CERTIFICATE OF APPROPRIATENESS PLACARD

422 N PERSON STREET

130-17-MW

- Install gravel parking pad and extend driveway
- Note: Due to the proximity of trees to the new parking pad, any digging will require hand excavation to protect nearby tree roots. Also, should any tree roots over 1" in diameter require cutting it must be done cleanly with a saw or loppers.

422 N. PERSON STREET
 RALEIGH, NC 27601

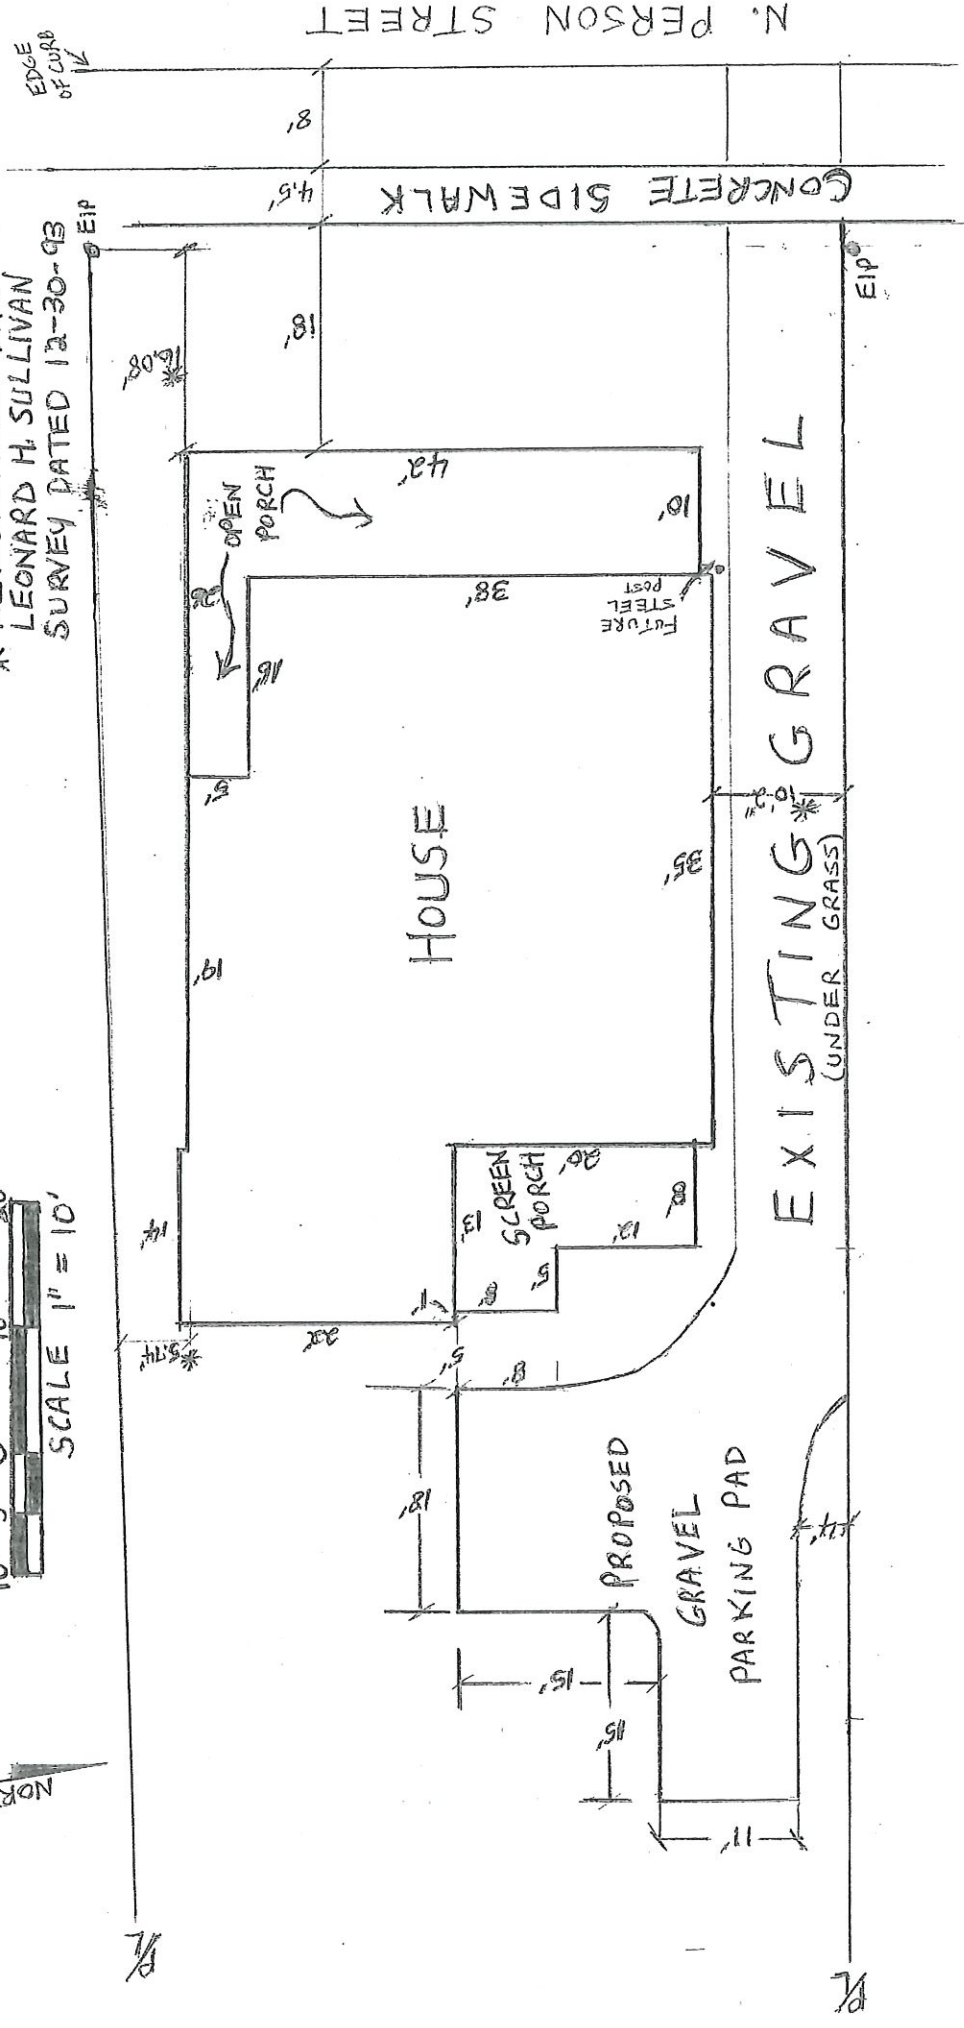
- I have learned that a longer driveway that extends into the backyard is not uncommon in Oakwood, and neither is a turnaround space. However, the scale of your proposed driveway and parking area is still an issue and doesn't clearly meet the [Design Guidelines](#). Your proposal increases the built area to open space by 10%. If you could modify the proposal so that it is a more modest increase, perhaps 5%, it would be more readily approvable. This would require a reduction of roughly 50% of the area currently proposed.
- It is unclear if there are any trees that will be impacted by the project. If there are, especially tree roots that might be under the new driveway, you'll need to have a tree protection plan.

In reviewing your COA application for the driveway project at 422 N Person St I have a few questions for you. Is there any evidence of a parking area where you propose the new parking pads? I understand the driveway that runs alongside the house has been there for some time, but can you see any indication that there was any such area to the rear?

- This first is that you are significantly increasing the amount of built area to open space vs. what is there now. It appears that the house with its two porches and existing gravel driveway cover approximately 33% of the lot, while the newly proposed parking pad and driveway increase the lot coverage to 43%. This is in direct conflict

with an important design guideline: "1.3.8 In the residential historic districts, it is not appropriate to alter the residential character of the district by significantly reducing the proportion of the original built area to open space on a given site through new construction, additions, or surface paving."

- The second is that the configuration is not appropriate for the historic district, as traditional driveways in Oakwood were straight runs that did not include the additional turnaround area you propose. The gravel you propose to use is a material that can be approved, however

- Redesign the layout to be both more compatible with the historic design of driveways in the district and smaller in surface area, or
- Provide evidence of the existence of a driveway/parking area like the one you propose through historical documentation or evidence on site.

Thank you for the kind advice about digging in the backyard for gravel. The attached plot plan for 422 N Person Street has been revised since the original submittal of June 30, 2017. The changes are as follows.

Holes were dug in backyard to determine locations of previous gravel. Sample locations #1 through #7 provide that gravel is present at these locations. The drawing and photographs #1 and #2 below show these locations. Photographs #3 and #4 show gravel dug from sample locations #2 and #4 placed on paper towels. On this basis, dashed lines are shown on the drawing to represent the presence of existing gravel. The garden hose in the photographs shows the location of the dashed lines in the drawing. The three rectangles A, B, and C in the drawing show an existing gravel surface of 491 square feet as shown in the table below.

A	5' x 10'	50 square feet
B	19' x 21'	399 square feet
C	6' x 7'	<u>42 square feet</u>
Total		491 square feet

Existing built area of 3826 square feet divided by property area of 9694 square feet equals 39.5%. The area of the proposed additional built area is 390 square feet and is summarized from the drawing in the next table.

8' x 18'	=	144 square feet
	11' x 18'	=	198 square feet
Near fence	4' x 7'	=	28 square feet

Triangle section near fence 20 square feet
Total 390 square feet

Existing built area of 3826 square feet plus additional built area of 390 square feet divided by 9694 square feet which equals 43.5%. This is an increase of 4%.
